ADDITIONAL FINAL NOTICE

DATE: May 19, 2022
TO: Blue Bird Owners
Subject: RECALL R19AF, Safe Fleet Prolo Roof Hatch Handle

IMPORTANT SAFETY RECALL NOTICE

OUTER HANDLE REPLACEMENT

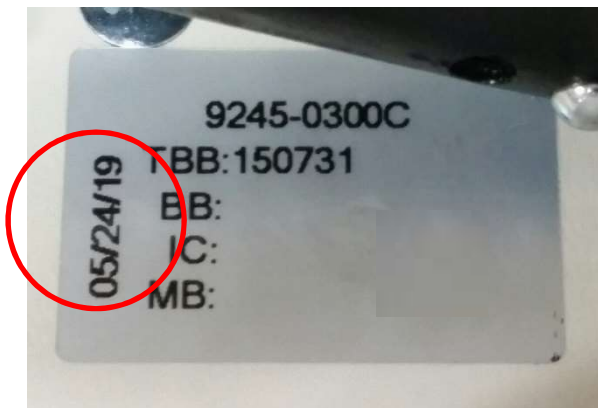
Step 2. Locate the silver “build date” sticker on the inside of the lid (located in red circle shown above)

Step 3: If the date is between 8-1-18 and 5-21-19, the hatch will need to be reworked. Dates before or after that timeframe do not need rework.

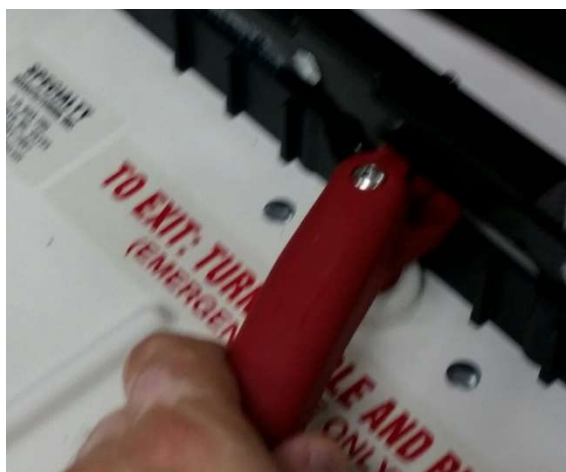
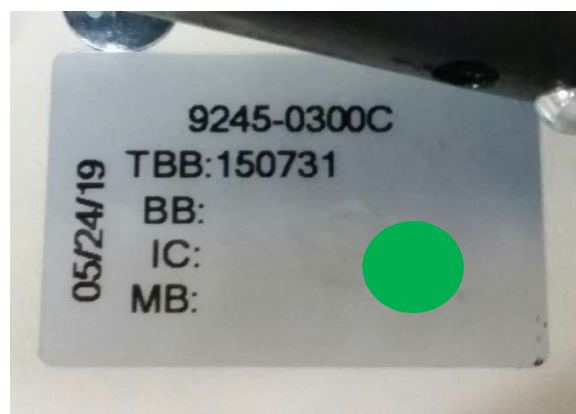
Step 17: Secure the lid to the trim subassembly by rotating the handle into position. There should be a “click” when the switch is activated. If a switch does not occur, the switch will need to be replaced.

Step 18: When the rework is complete, place a green sticker on the silver sticker.

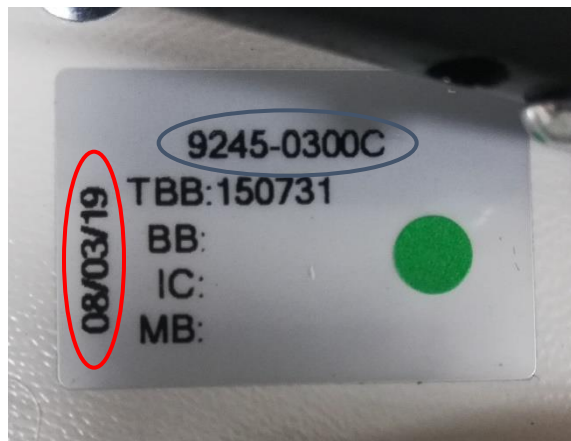
1. Check the label on the bottom of the Prolo Hatch p/n 92XX-XXXXX (circled below in blue) for dates between August 1, 2018 and May 20, 2019 (circled below in red). Units built within this date range are subject to the replacement campaign.

Replacing the outside release handle will resolve the defect. The replacement kit will include (1) replacement handle, associated hardware, and replacement instruction information.
